marantz® SERVICE BULLETIN		Date: 15-May-2003	Model: SR5200/SR6200/SR7200
		Page: 1/2	REF.NBR: MZ02-033
Circulation:		Subject:	
Application:		Hum noise can be heard from Headphone out.	
x for information customer complaint in case of service mandatory			
See below

marantz® SERVICE BULLETIN		Date: 15-May-2003	Model: SR5200/SR6200/SR7200
		Page: 1/6	REF.NBR: MZ02-032
Circulation:		Application:	
x for information customer complaint in case of service mandatory		See below	
		Subject: Pop noise	
		Int.ref:

marantz® SERVICE BULLETIN		Date: 15-May.-2003	Model: SR5200,SR6200,SR7200
		Page: 1 / 1	REF.NBR: MZ02-027
Circulation:		Application:	
x for information customer complaint in case of service mandatory		See Below	
		Subject: Video synchronization problem.	
		Int.ref:

marantz® SERVICE BULLETIN		Date: 27-Sep-01	Model: SR5200/6200/7200
		Page: 1/2	REF.NB MZ01-016
Circulation:		Application:	
x for information customer complaint in case of service mandatory		Refer to following.	
		Subject: The noise (stripes) occur on the picture.	
		Int.ref

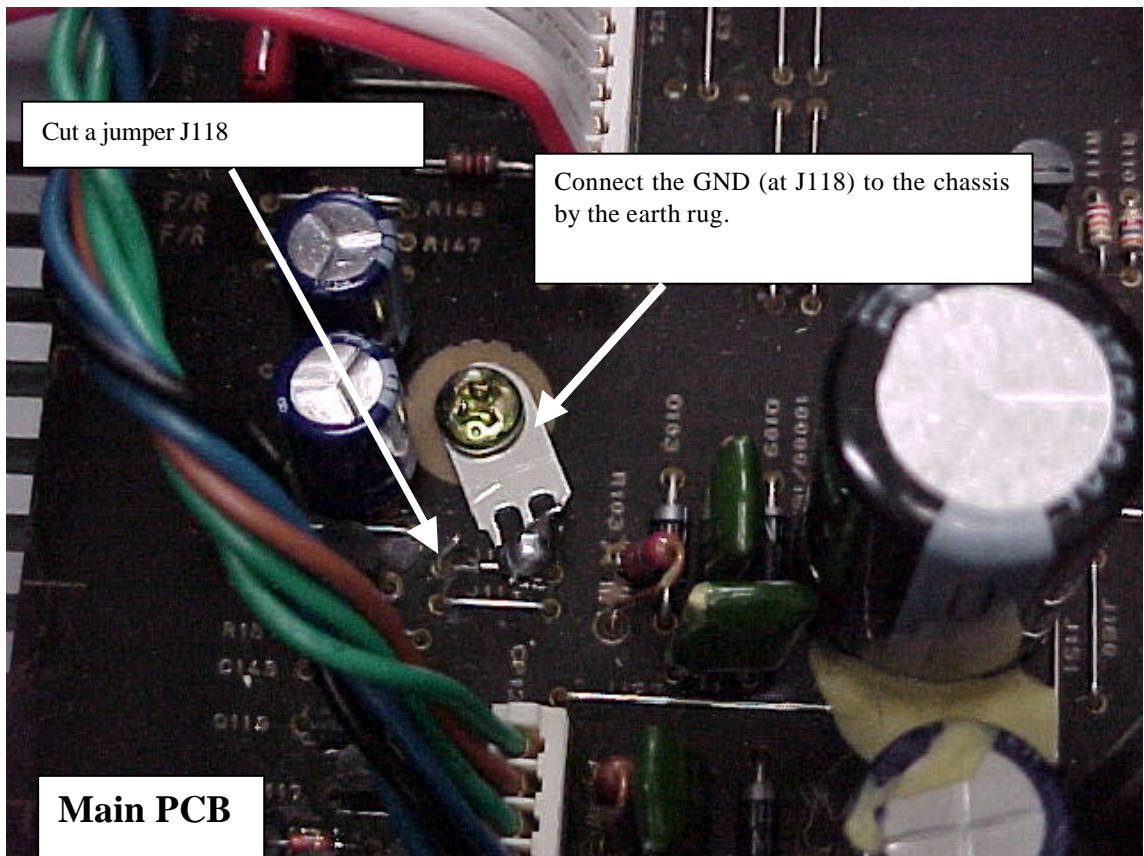
Hum noise can be heard from Headphone out

Caused by ground loop of the headphone out.

Please apply the following solution.

* Version 1 P.C.Board (7020 06076 001-0) : Please apply the modification mentioned below (Page2 to 4).

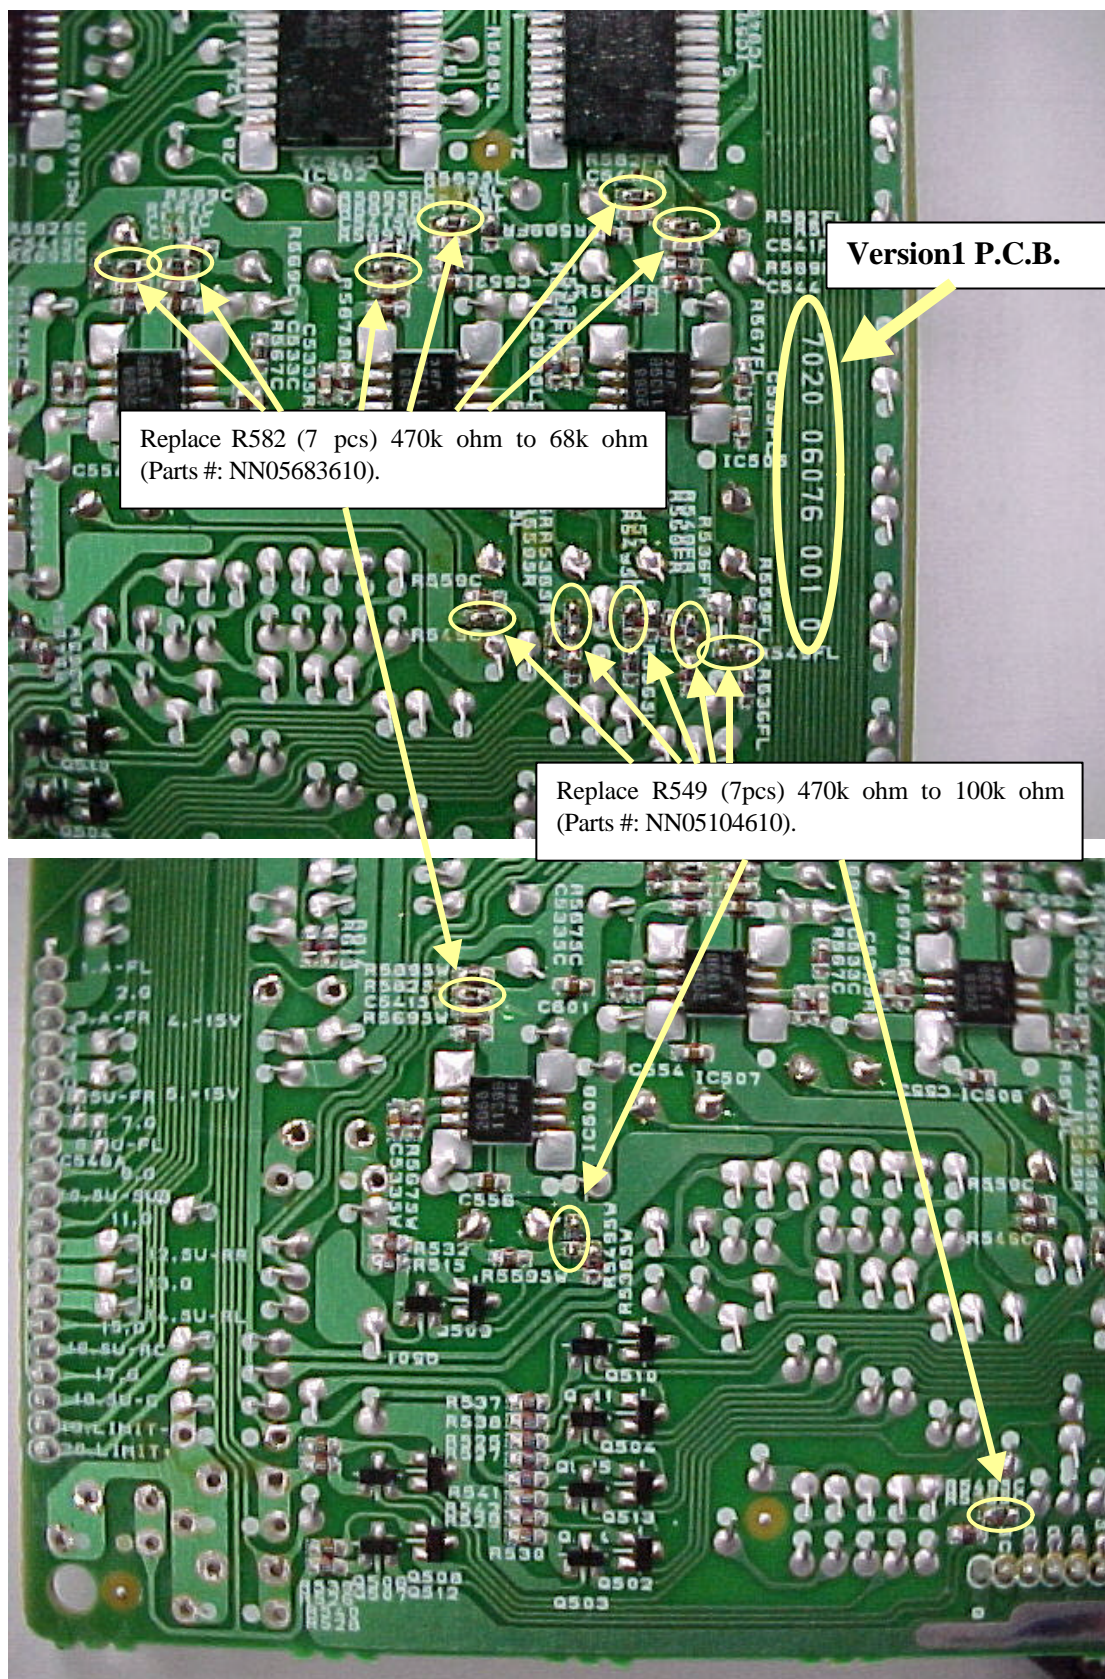
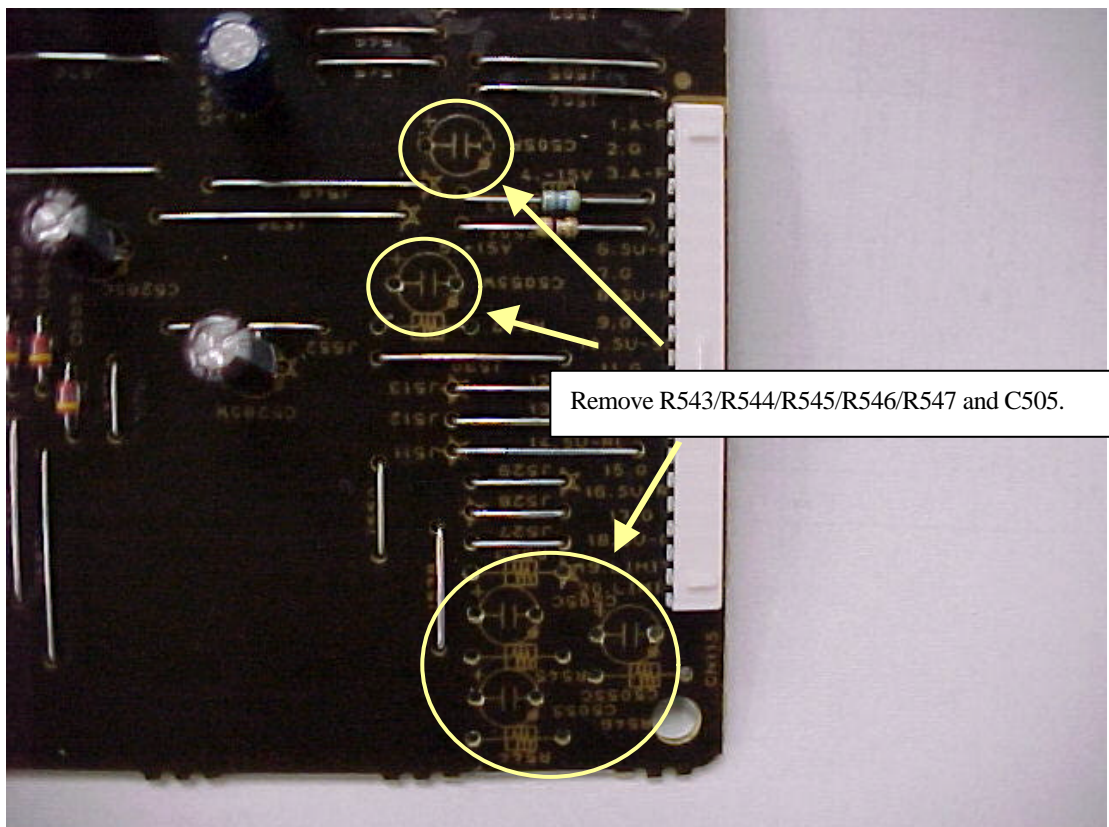
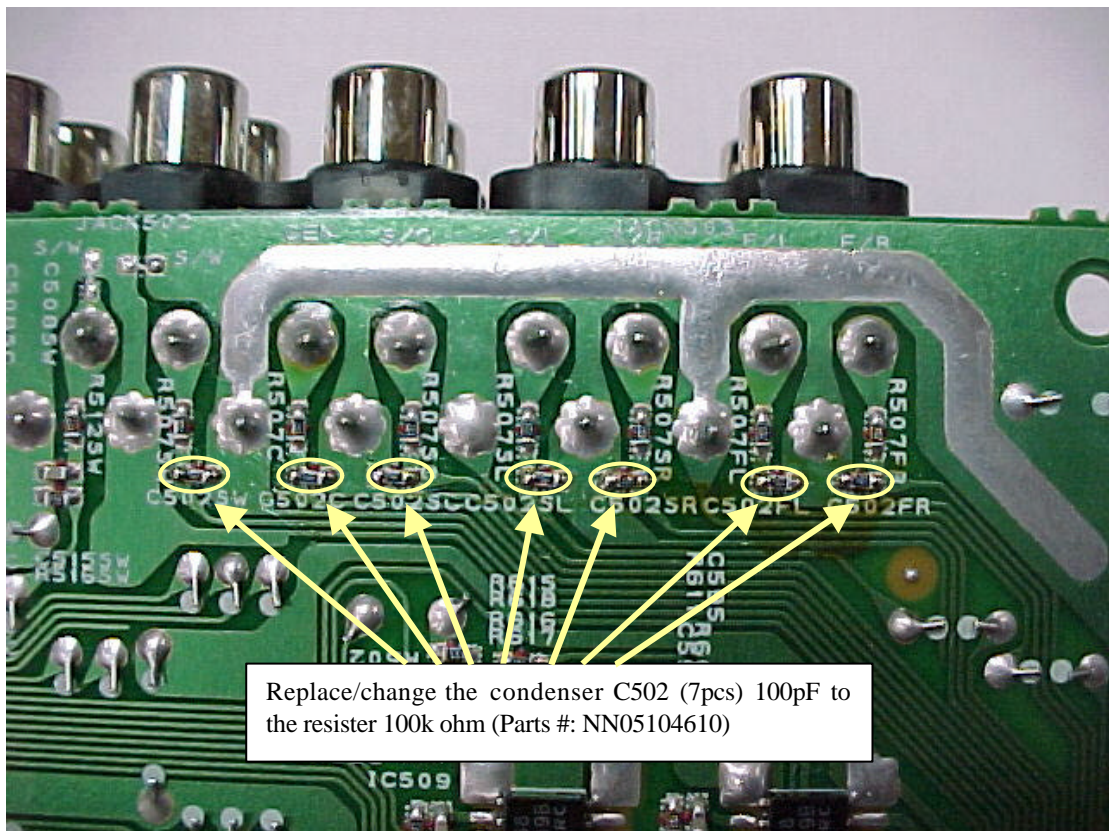
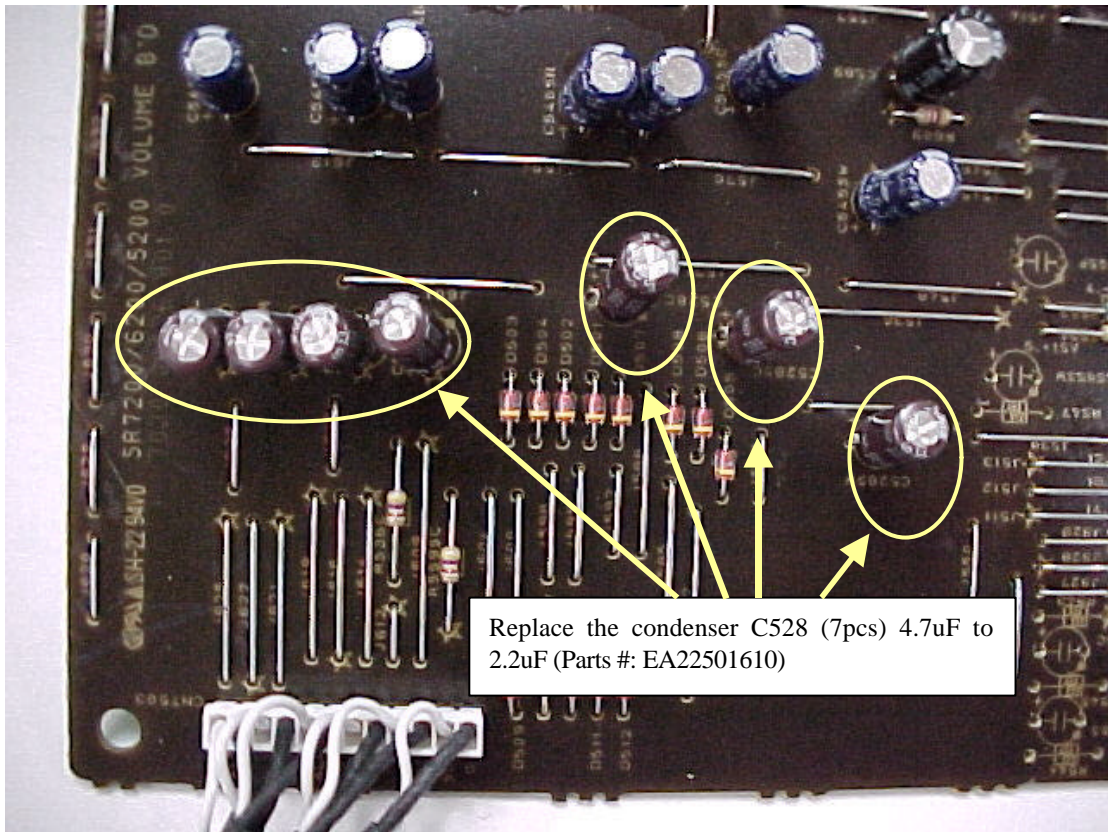
Pop noise appears when stop playing or track skip on CD playback with Digital connection.
Pop noise appears in the condition of the Main volume is changed 74dB to 75dB(Mute) .

* Version 1 P.C.Board (7020 06076 001-0) : Please apply the modification mentioned on Page2 to 4.

PIC.01

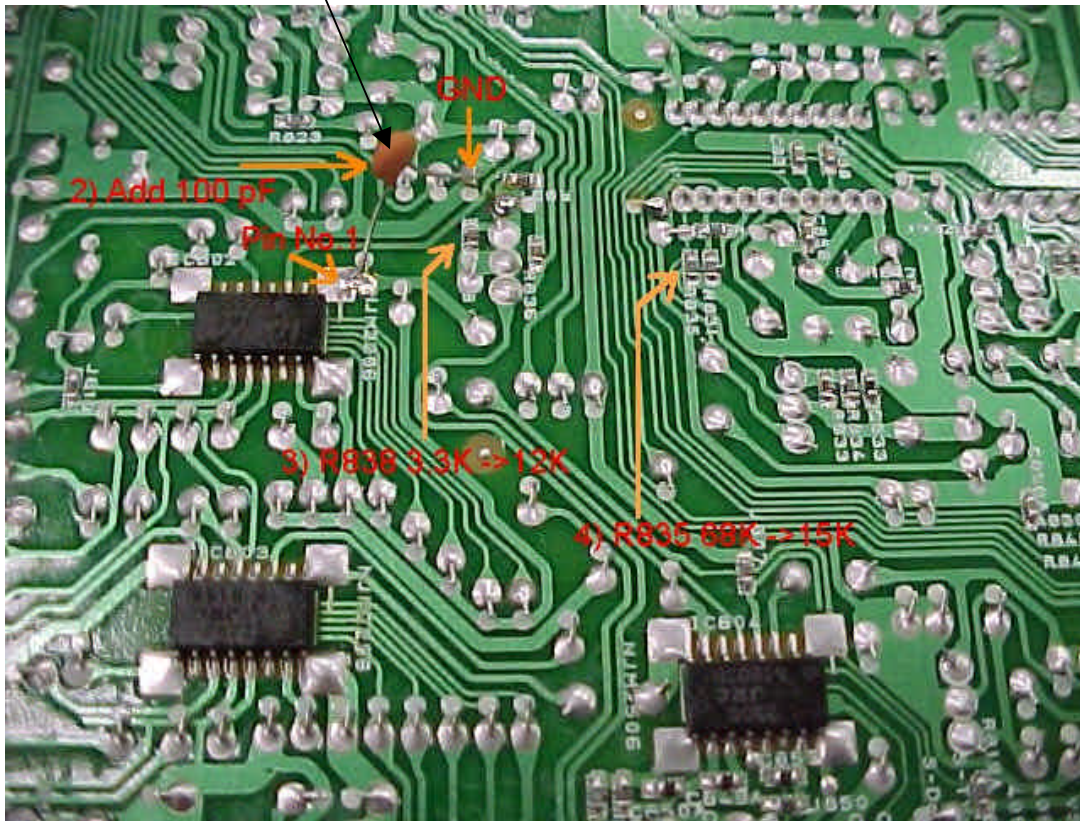
When a output connect with the monitor via the S-VIDEO terminal, noise(stripes) occur at the picture.

The clock from the OSD circuit, it caused interference to VIDEO-AMP circuit.

- 1) The capacitor(C810A 100pF: DK16101300 4822 122 33195) is added between 1P of IC802 and GND(refer to PIC.01).
- 2) The jumper wire(J841) is deleted and a capacitor(C840A 47uF/16V: EA47601620 9965 000 06289) is added to same position (refer to PIC.02).
- 3) The chip resistor(R838) is changed into 12kohm one(NN05123610 4822 051 30123) from the present 3.3kohm one.
- 4) The chip resistor(R835) is changed into 15kohm one(NN05153610 4822 051 30153) from the present 68kohm one.

C810A (100pF: DK16101300

4822 122 33195)
